**Seventh Interim Collection
1996–1997 NESC® Interpretations**

**Seventh Interim Collection
of the
National Electrical Safety Code®
Interpretations**

Abstract: This edition includes official interpretations of the National Electrical Safety Code as made by the Interpretations Subcommittee of the National Electrical Safety Code Committee, ASC C2.

Figure IR 504-1

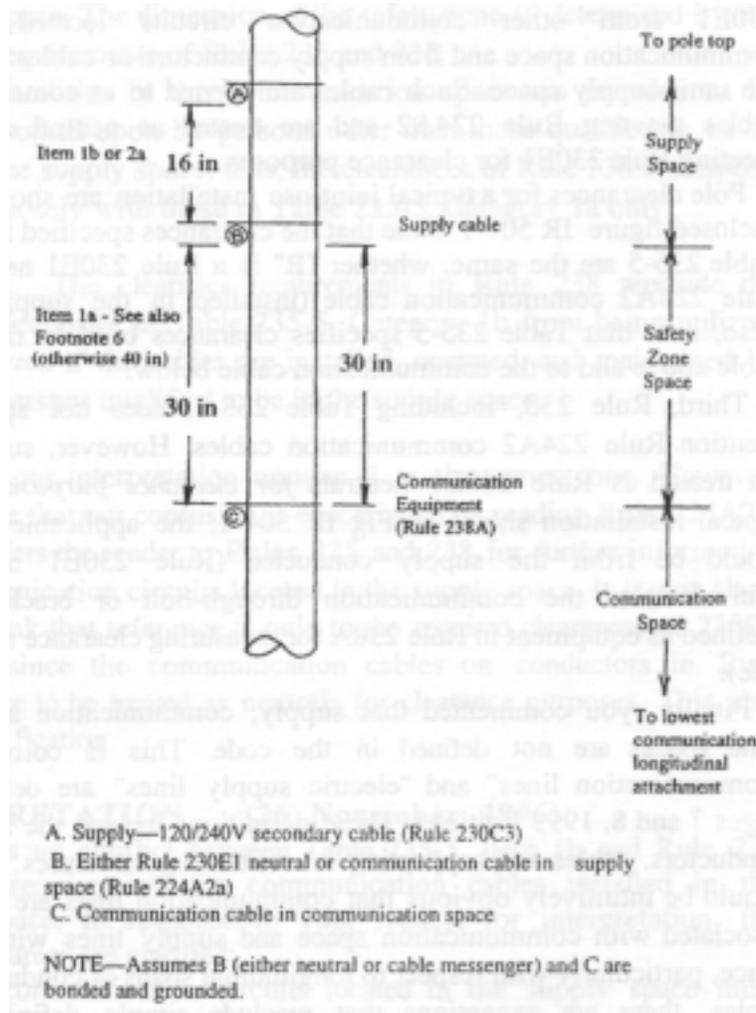
Table 235-5 appears to allow communication conductors and cables to be installed in close proximity to supply conductors and cables in Category 1b as compared with Category 1a. However, there does not appear to be any stipulation as to when, and under what condition, that is allowed. Rule 238 has the requirements for clearances between communication facilities and supply facilities and has greater clearance requirements than in Table 235-5, Category 1b. This seems to be ambiguous and incomplete, with a need for clarification. It appears that if we install communication cables in the supply space in accordance with Table 235-5, Category 1b, we will then be in violation of Rule 238.

We think our interpretation number 1 is the correct one. However, please note that our confusion is exacerbated by reading Rule 224A2a, since it refers the reader to Rules 235 and 238 for further information on communication circuits located in the supply space. It is not clear, but we think that reference is only to the required clearances of 230E1 neutrals, since the communication cables on conductors in Rule 224A2a are to be treated as neutrals for clearance purposes. This also needs clarification.

Pole clearances for a typical joint-use installation are shown in the enclosed figure IR 504-1. Note that the clearances specified for "B" in Table 235-5 are the same, whether "B" is a Rule 230E1 neutral or a Rule 224A2 communication cable (installed in the supply space). Also, note that Table 235-5 specifies clearances both to the supply cable above and to the communication cable below.

Third, Rule 238, including Table 238-1, does not specifically mention Rule 224A2 communication cables. However, such cables are treated as Rule 230E1 neutrals *for clearance purposes*. In the typical installation shown in Fig IR 504-1, the applicable clearance would be from the supply conductor (Rule 230E1 neutral or equivalent) to the communication through-bolt or bracket below (defined as equipment in Rule 238A for measuring clearance under this rule).

Finally, you commented that supply, communication and safety zone spaces are not defined in the code. This is correct. Both "communication lines" and "electric supply lines" are defined (see pages 7 and 8, 1993 Edition). These definitions include the associated conductors, cables and supporting or containing structures. While it should be intuitively obvious that communication lines are generally associated with communication space and supply lines with supply space, particularly with respect to longitudinal spans of conductors and cables, there are exceptions that preclude simple definitions. A generalized space allocation for the typical installation is also shown in Fig IR 504-1.
